## ADDENDUM

Ref No.: **6915**

ADDENDUM NO.: **01**

**RE: FIRE STATION NO. 243  
SITE, VENTILATION AND FIRE ALARM SYSTEM UPGRADES**

**ELECTRICAL**  
**SITE PLAN AND DETAILS**

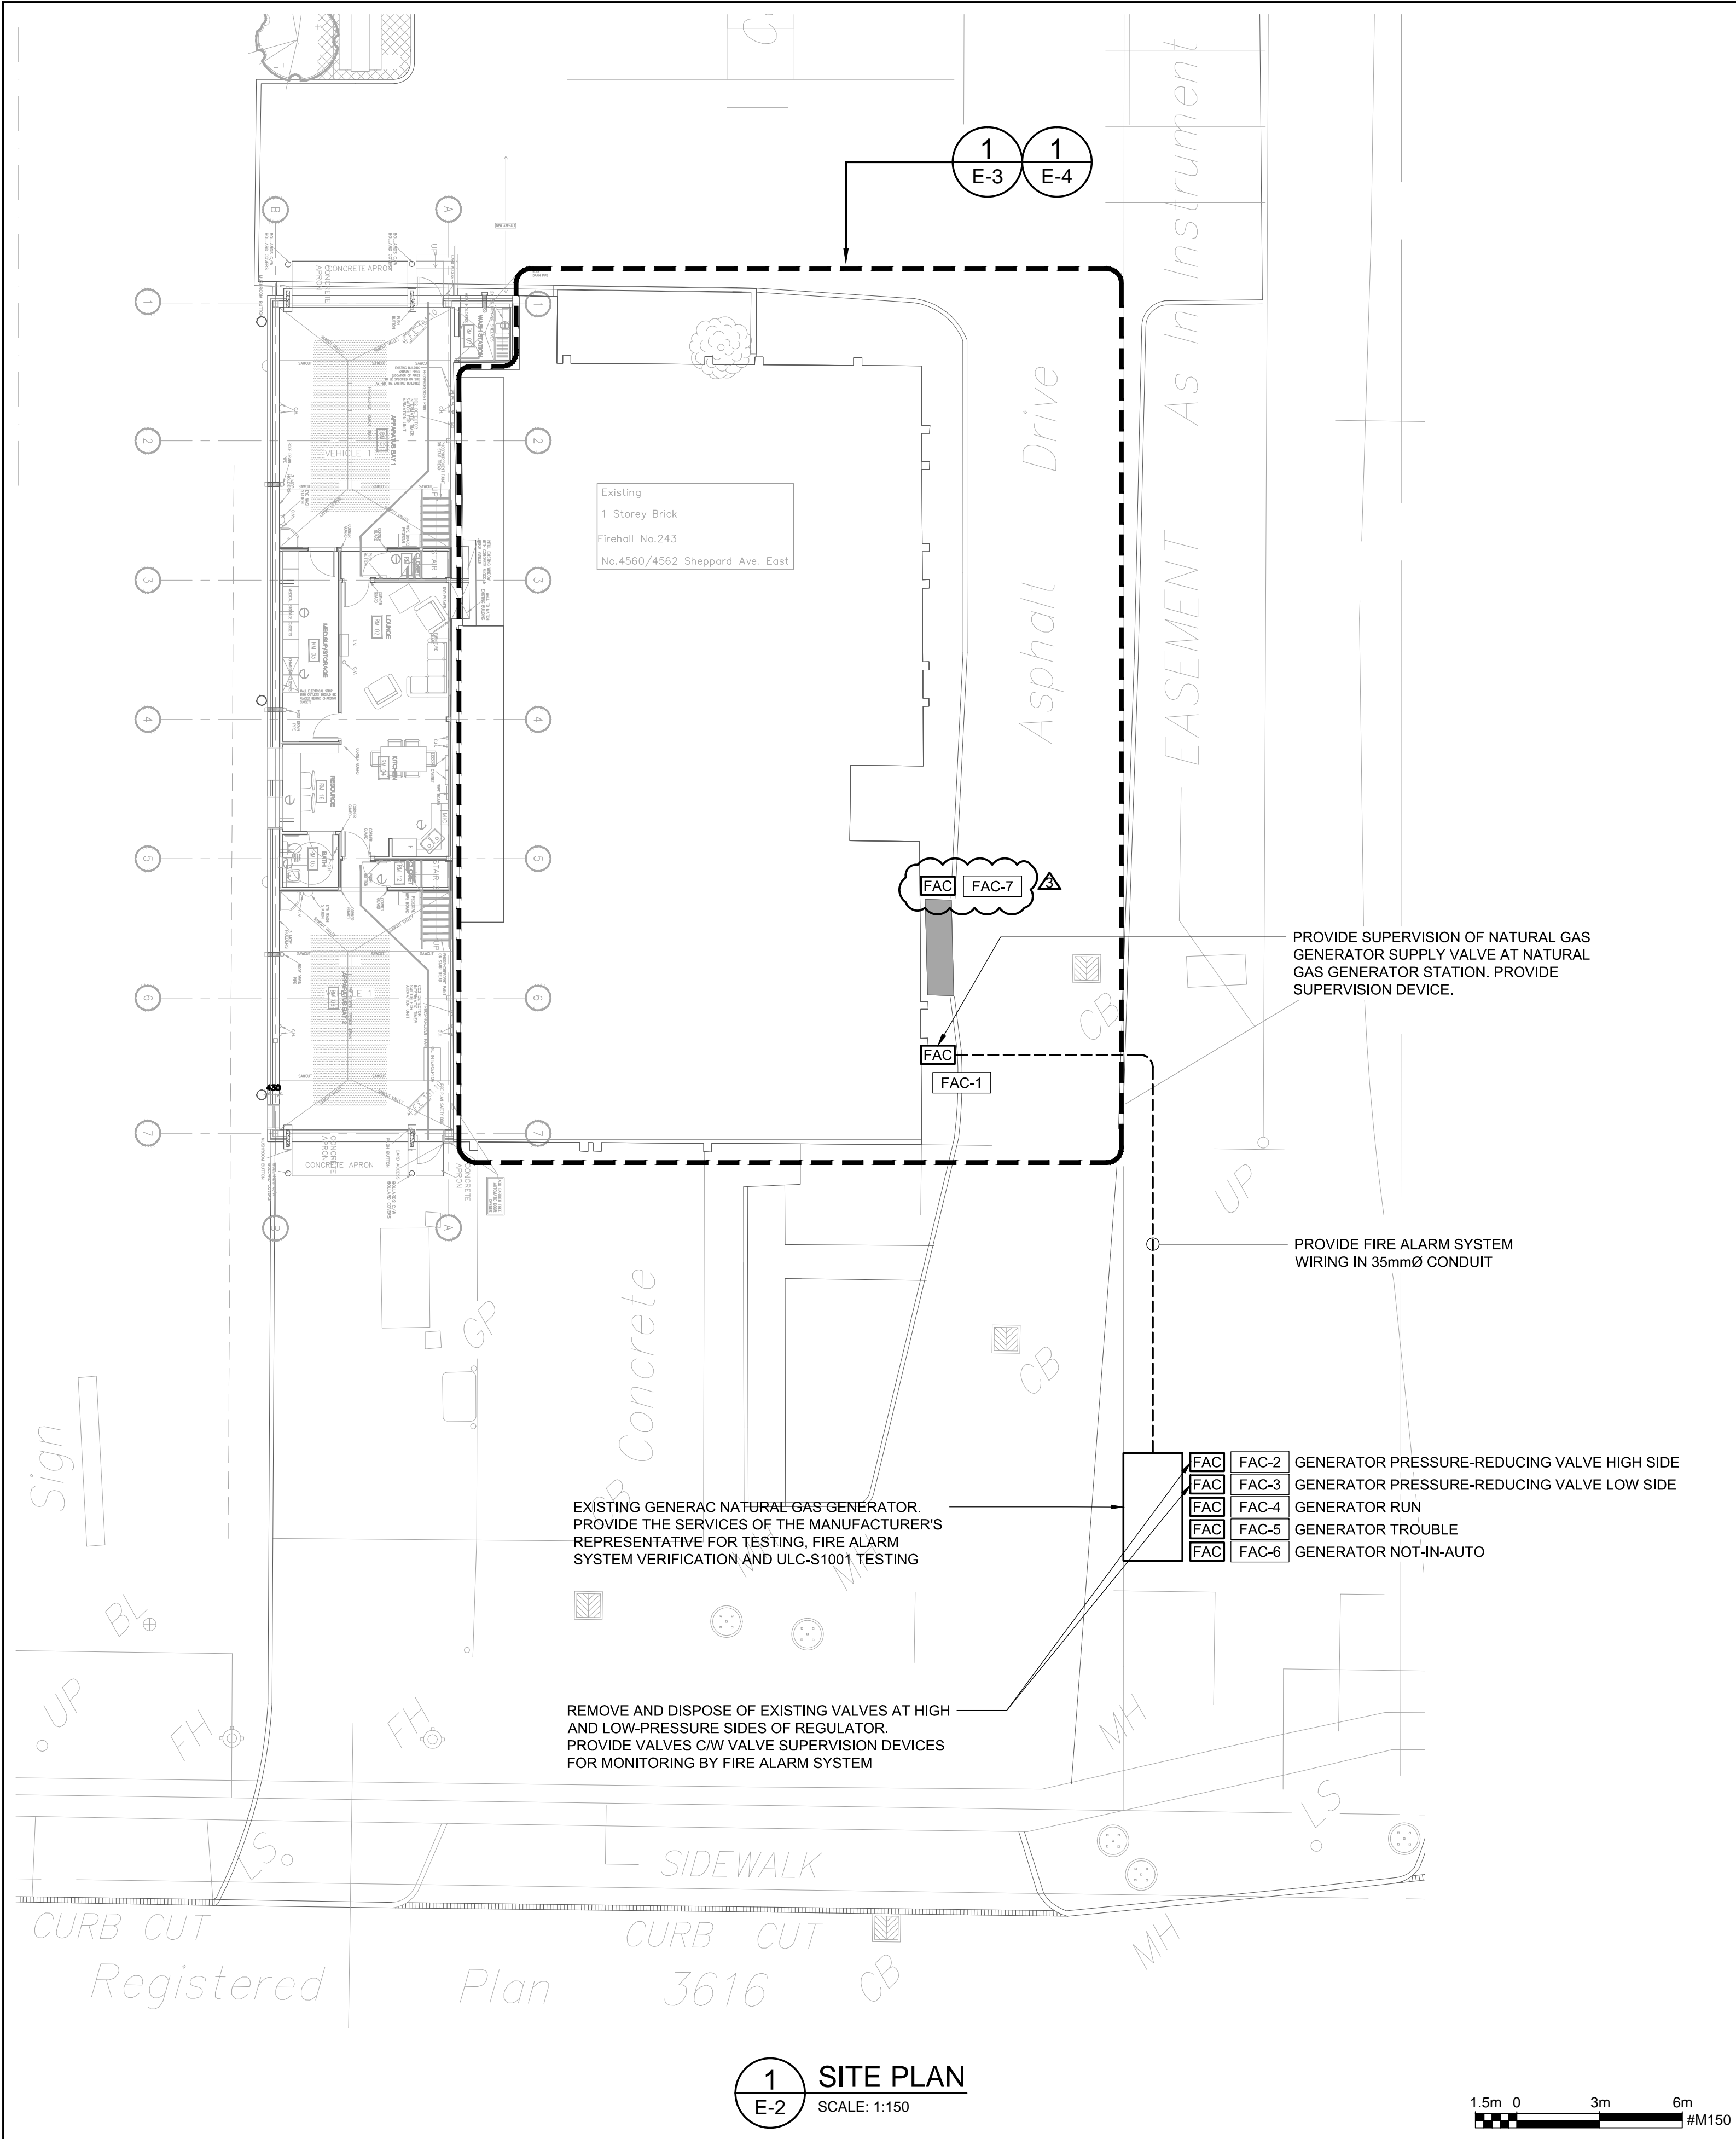
- .4 Added swale detail.
2. Reference Drawing E2, "Electrical Site Plan and Details"
  - .1 Refer to revised drawing Revision 3 - Issued for Addendum No. 1, Dated Apr. 22, 2025.

- .2 Added supervised valve. This valve shall be designated fire alarm connection no. 07 (FAC-7).
3. Reference Drawing E4 "Electrical First Floor Proposed Plan"
